STATE OF DELAWARE
EXECUTIVE DEPARTMENT
OFFICE OF
STATE PLANNING COORDINATION

RE: PLUS review – PLUS 2004-09-08; Middletown Auto Mall

Middletown Auto Mall

2004-09-08

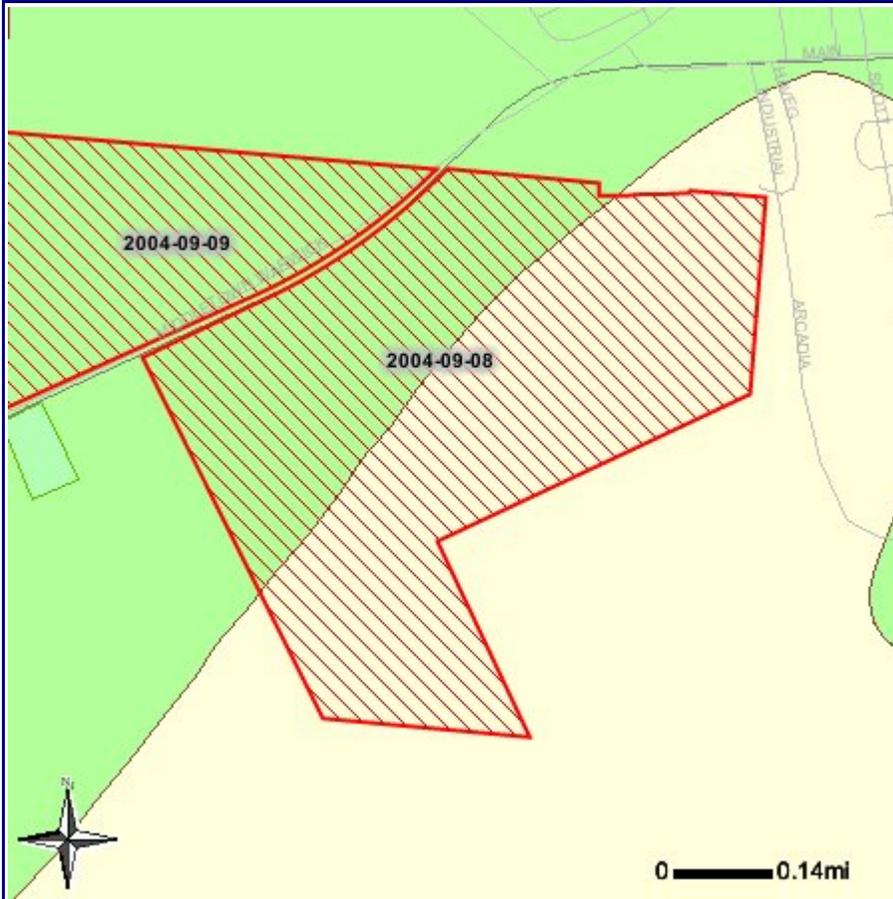
The entire parcel is located in an excellent recharge area (see map). According to the State law that created the Source Water Protection Program, county and municipal governments will be required to enact ordinances to protect Water Resource Protection Areas. The following language has been excerpted from the draft Source Water Protection Guidance Manual for Local Governments, Supplement 1 - Ground-Water Recharge Design Methodology. While the language is currently draft and the local ordinances are not yet in place, the developer may find the language useful in modifying the site plan to protect the excellent recharge area.

Water Resource Protection Areas (WRPAs) are defined as (1) surface water areas such as floodplains, limestone aquifers, and reservoir watersheds, (2) wellhead areas, or (3) excellent recharge areas. The purpose of an impervious cover threshold is to minimize loss of recharge and protect the quality and quantity of ground and surface water supplies in WRPAs.

New development in WRPAs may exceed the 20 % impervious cover threshold, but be no more than 50 % impervious, provided the applicant submits an environmental assessment report recommending a climatic water budget and facilities to augment recharge. The environmental assessment must document that post-development recharge will be no less than predevelopment recharge when computed on an annual basis.

Commonly, the applicant offsets the loss of recharge due to impervious cover by constructing recharge basins that convey relatively pure rooftop runoff for infiltration to ground water.

- 1) Preserve WRPA's as open space and parks by acquisition or conservation easement.
- 2) Limit impervious cover of new development to 20 % by right within WRPA's.
- 3) Allow impervious cover of new development to exceed 20% within WRPA's (but no more than 50% impervious) provided the applicant develops recharge facilities that directly infiltrate rooftop runoff.
- 4) Allow impervious cover of new development to exceed 20% within WRPA's (but no more than 50% impervious) provided the applicant develops recharge facilities that infiltrate stormwater runoff from forested and/or grassed surfaces with pretreatment.
